[To:](#) Stanley.Lyles@fcc.gov
[Cc:](#)
[Bcc:](#)
[Subject:](#) Re: Fw: FCC Equipment Authorization System

Re: FCC ID: QISAP505130DN

Applicant: Huawei Technologies Co.,Ltd
Correspondence Reference Number: 46318
Form 731 Confirmation Number: EA154006
Date of Original E-mail: 08/20/2014

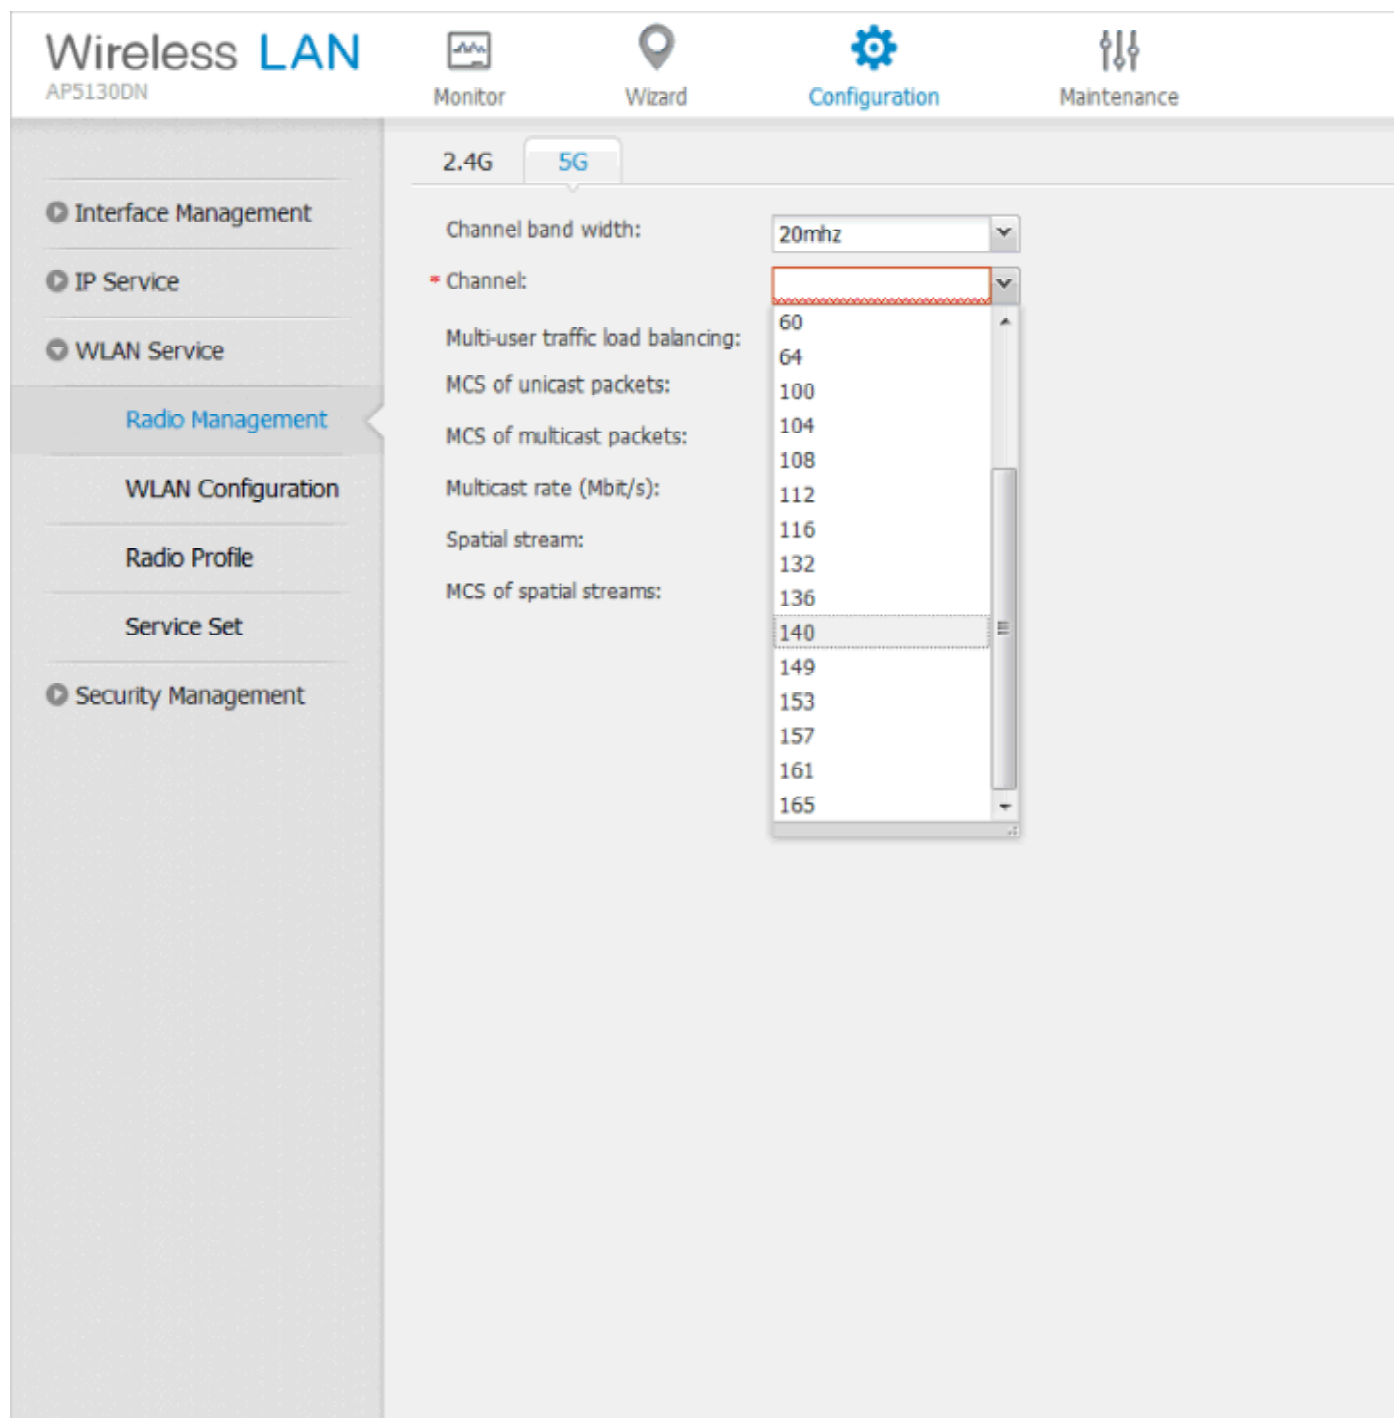
In the review of GUI we found that channel 144, 20 MHz was listed in the initial channel listing. The use of this channel is allowed under old rules. However, this must follow the KDB publication 644545 D01 Guidance for IEEE 802.11ac v01r02, sections E)3)a), F)2) and F)3) for compliance. Otherwise, this channel must be removed from the listing.

Thanks for your guidance! Sorry but we checked the GUI interface and found there is no channel 144 in the channel list, please see below scanshot for your reference.

So we feel confused why this hanppened. Would you mind sending us a scanshot for the channel 144?
